## HySecurity Hydraulic Products

**SUBJECT:** Certain HySecurity gate operators may have an incorrect valve coil.

**DATE:** 12/2024

Figure 1. SlideDriver II Pump Pack

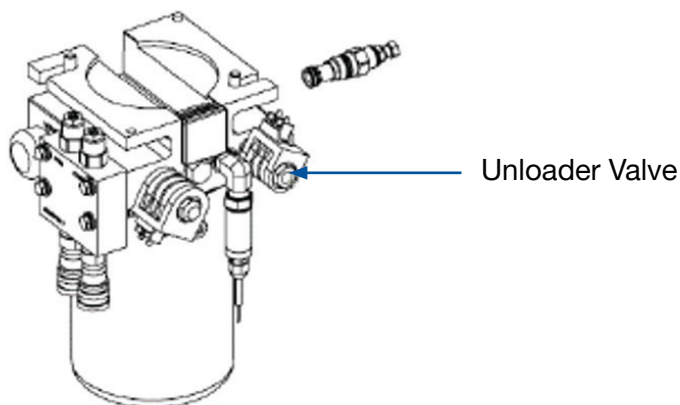
Some pump packs on the subject operators were manufactured using 12VDC valve coils on the unloader valve, rather than 24VDC coils.

Only the unloader valve is affected (displayed below):

Coil Voltage is embossed on the plastic housing.

**12VDC - INCORRECT**

Coil Voltage is embossed on the plastic housing.

**24VDC - CORRECT**

Replace the coil (PN: MX000185). Contact your Sales person or Technical Support for replacement coils.
